1985 Corvette: Service News: Revised Differential Case Cross Pin Installation Procedure

Subject: Revised Differential Case Cross Pin Installation Procedure

Model and Year: 1985 Corvette

Date: March/April 1985 - Volume 57 - Number 2

Fig. 4 — Installing Cross Pin

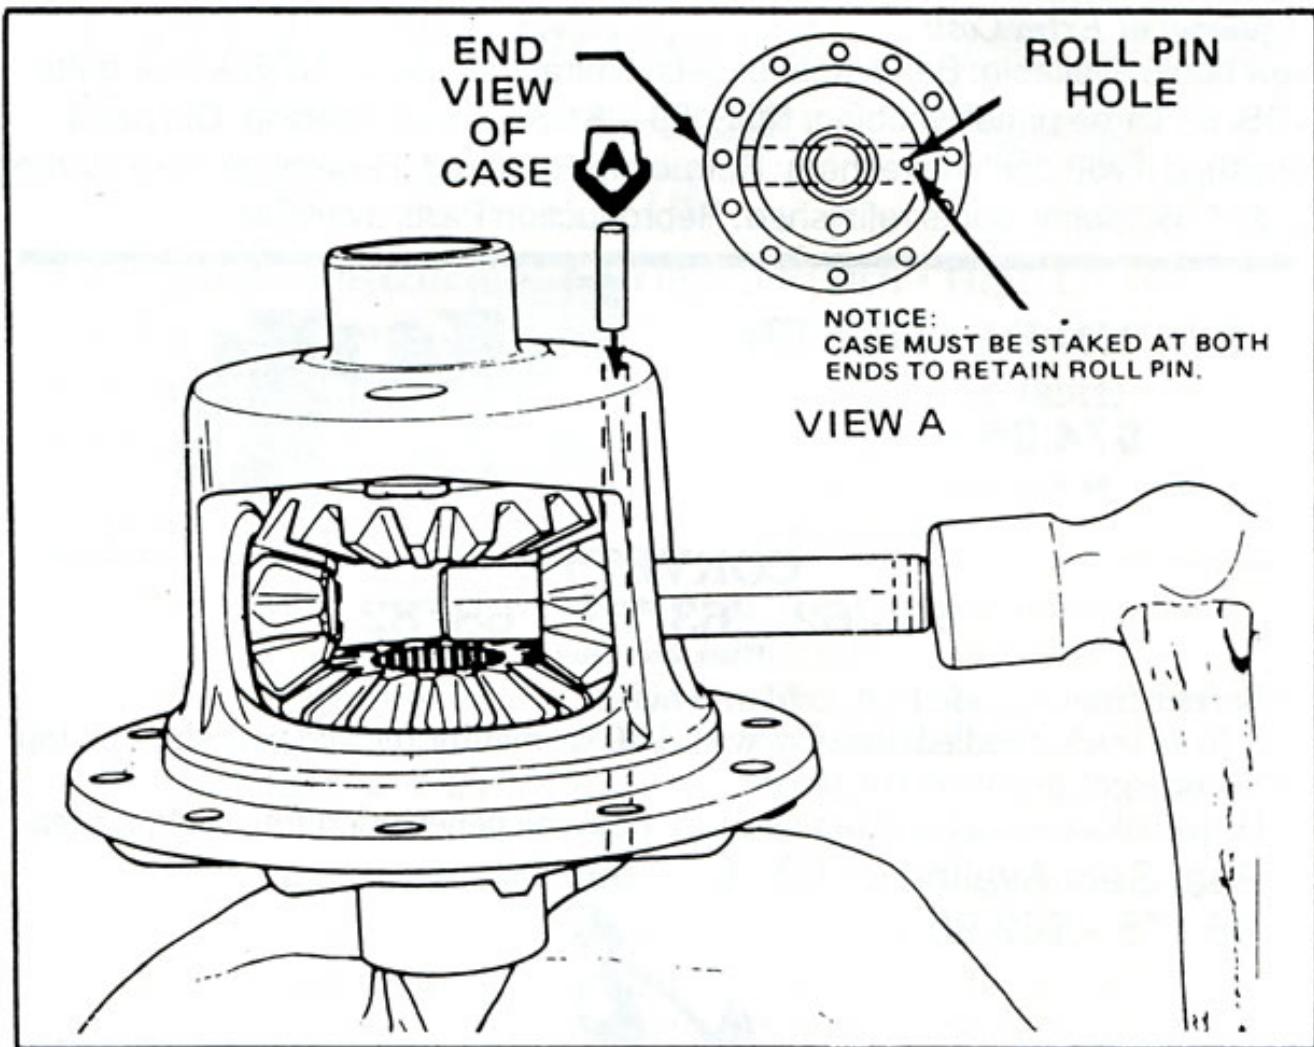
Figure 4B-39 shown on Page 4B-16 and step 10 shown on Page 4b-17 of the 1985 Corvette Shop Manual (ST-364-85) have been revised as indicated below. Fig. 4 replaces Figure 4B-39 presently shown in the Shop Manual.

10. Position the cross pin shaft in the case and drive in with a hammer. Be sure the retaining pin hole of the cross pin shaft is properly aligned to allow installation of the retaining pin. Install the retaining pin to the proper depth using a punch and stake in place at both ends of the case.
